Interactive comment on “Projected changes in US erosivity” by M. Biasutti and R. Seager

M. Biasutti and R. Seager

Received and published: 13 May 2015

Fig. 1. New Figure (Figure 11 in current manuscript)

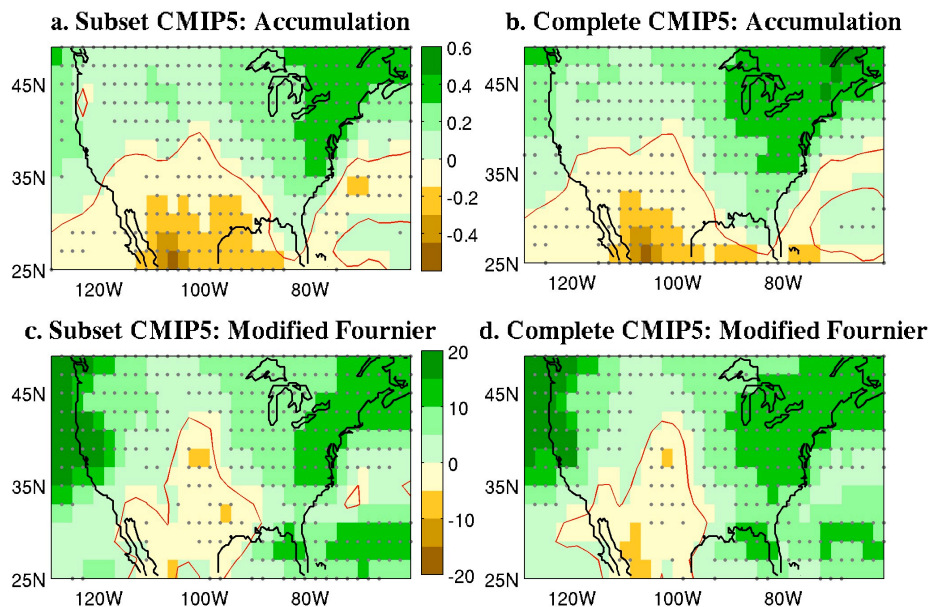
Reviewer B's main issue with the substance of our study is cited as follows: [...] *the uncertainty from climate models (using the 21 simulations) is rather superficially addressed in Figs. 10-12. We regret that we did not present a more fuller picture of the uncertainty due to climate models. No doubt, this stems from the fact that we are more familiar with that literature and took it too much for granted. We have now added one figure that goes some way into addressing this issue (the new figure is reproduced at the end of this response). We have also added more reference to the relevant literature. The new figure shows the projections in mean accumulation and in the modified Fournier index in the 21 models that were used in the downscaled dataset and in a*

P. 1488, L. 16-18: I am not convinced, because your analysis of the uncertainty from climate models is rather superficial. As mentioned above in our answer to the general comments, we have added a figure that address uncertainty ion rainfall projections in

much larger ensemble (38 CMIP5 models, some of them with several ensemble members). This analysis allows us to comment on the role of the downscaling technique (in some regions downscaling changes the sign of future anomalies) as well as on the role of model choice and ensemble size.

a more detailed way and we have expanded Section 3 to include better references to the literature and a clearer indication of where in the US the uncertainty in the climatic signal is less consequential than the uncertainty in the relationship between rainfall accumulation and erosivity. Confident that the new manuscript makes our case more solidly, we have edited this paragraph to clarify what we mean. It now reads:
